# 17-087CU/DPR/SPR/PP/FP – TOWNEPLACE SUITES HOTEL

## Proposal

Conditional Use (CU), Administrative Departures (AD), Waiver Review (WR), Development Plan Review (DPR) and Site Plan Review (SPR) for a 64,000-square-foot hotel and surface parking lot.

**8) Stormwater Management & Utilities**

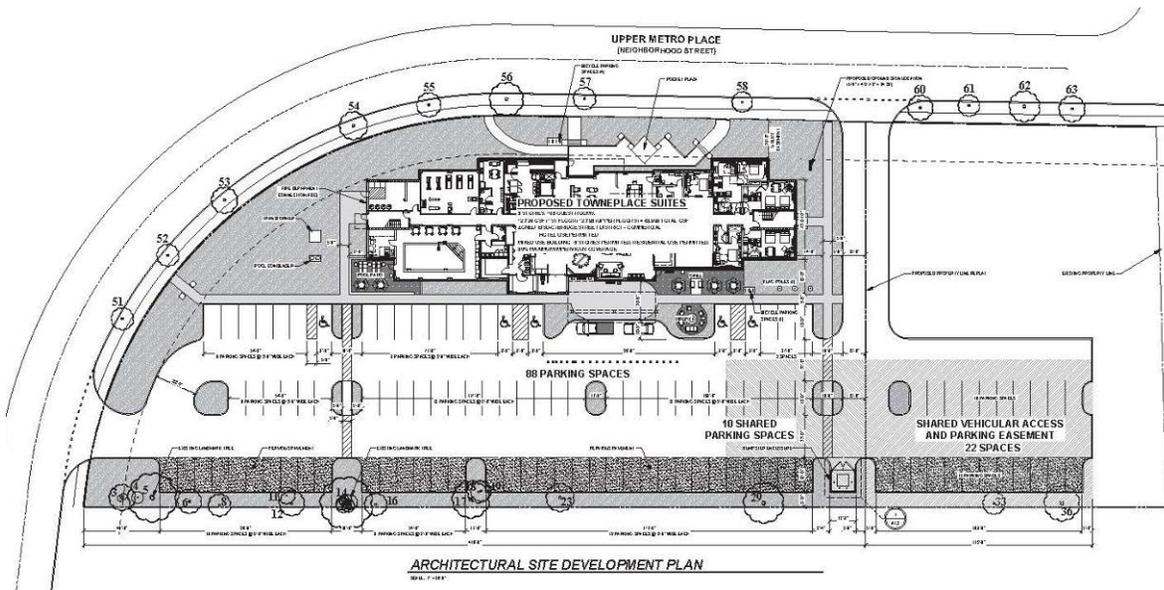
The applicant has provided stormwater management details for the proposed system including underground storage, bio-swales, and permeable pavement. The applicant will need to work with Engineering to demonstrate continued compliance with the

stormwater requirements as defined by Chapter 53 to the satisfaction of the City Engineer.

The site will be served by public utilities located on the south side of Upper Metro Place with sanitary and water provided within the existing utility easement. Additional private utilities are located within the easement and the applicant will need to rectify any conflicts between proposed landscaping design elements such as stone columns, wall, pavers, or similar and the existing public and private utilities prior to filing for building permits.

10. That the applicant work with Engineering to demonstrate continued compliance with stormwater requirements as defined in Chapter 53 to the satisfaction of the City Engineer; and,
11. That the applicant rectify any conflicts between the landscaping design elements (stone columns, walls, pavers, etc.) and the existing utilities prior to filing for building permits.
